STATE OF WASHINGTON  
DEPARTMENT OF ECOLOGY

**Re: Opinion Pursuant to WAC 173-340-515(5) on Proposed Remedial Action for the Following Hazardous Waste Site:**

- **Name:** L & E Auto Sales
- **Address:** 227 Naval Ave & 2101 Burwell Pl, Bremerton, WA 98312
- **Facility/Site No.:** 14170
- **VCP No.:** NW2785
- **Cleanup Site ID No.:** 11943

**FIGURE 4 Site Map**  
 Project Name: Burwell Place  
 Location: Bremerton, Washington  
 Project: ESC13-E002  
 Client: Frick N Frack Holdings LLC  
 Date: May 2013

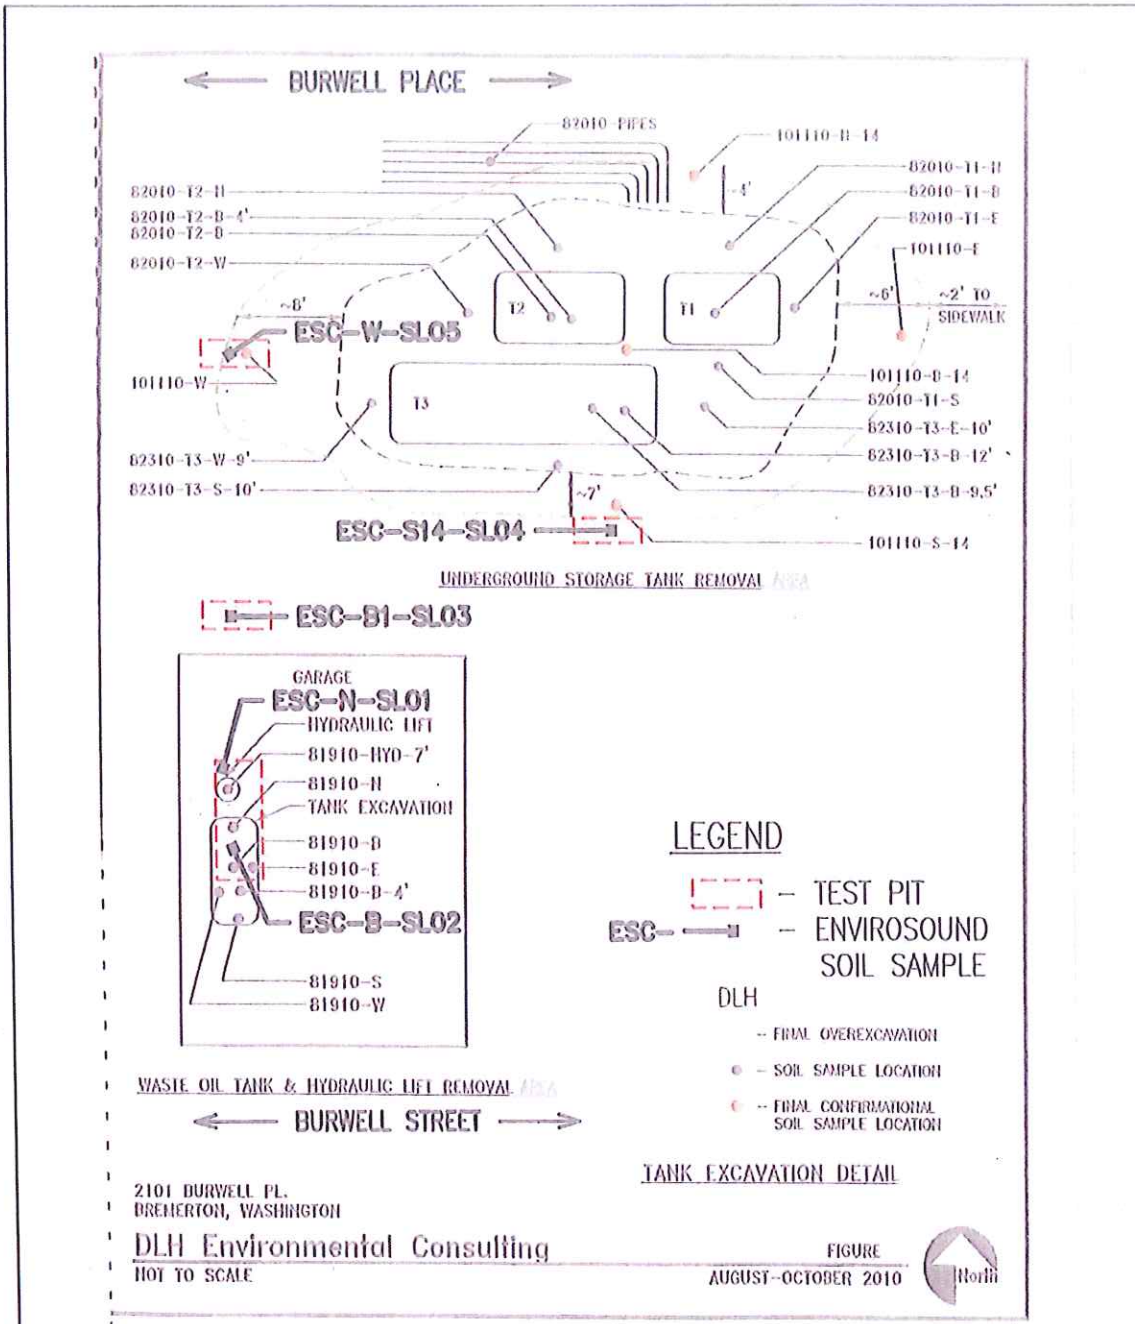
- The characterization of this Site is not complete. *Guidance for the Remediation of Petroleum Contaminated Sites*, Ecology Publication No. 10-09-057, September 2011 provides additional information regarding site characterization at petroleum release sites. At the gasoline tank excavation area, extensive soil contamination was encountered at depths between 8 feet below ground surface (bgs) and 12 feet bgs. However, the final limit of excavation sidewall soil samples were collected at 14 feet bgs or greater. Sidewall soil samples are required at the correct depth intervals to provide bounding data for the lateral extent of soil contamination. In addition, only one base sample was collected between the former tank locations. Because of the elevated concentrations of TPHg and BTEX beneath each tank, additional sampling is needed to establish vertical extent below the former tank locations. Sampling beneath the locations of the former dispenser islands is also required. Finally, there is no indication of why only TPHg and BTEX were analyzed for in samples collected in the vicinity of the three tanks. Was there some historical indication that only gasoline was stored in the tanks? If not, future samples should be analyzed for TPHd until TPHd can be eliminated as a potential contaminant of concern in this area of the Site.

The vertical and lateral extent of soil contamination at the former waste oil tank is similarly not clear. Soil sample ESC-B-SL02 appears to have been collected within the limits of the previous waste oil tank excavation backfill, and does not provide additional information on the extent of contamination north of sample 81910-N. In addition, this sample was collected above the bottom of the former excavation and does not provide the bounding data necessary to establish the vertical extent of contamination. Sample EXC-N-SL01 is not located within the depth range of contamination previously observed at the waste oil tank, and similarly does not

provide lateral bounding data north of the former waste oil tank. Field screening indications during excavation of test pits is not acceptable as bounding data for lateral extent of contamination. This is similarly true in the vicinity of boring B-1 where lateral extent samples are necessary in the contaminated zone identified at 6 feet bgs to define the extent of TPHd and TPHo. Complete Site characterization is a necessary prerequisite for determining an appropriate cleanup action and cleanup standards and to determine the adequacy of cleanup actions.
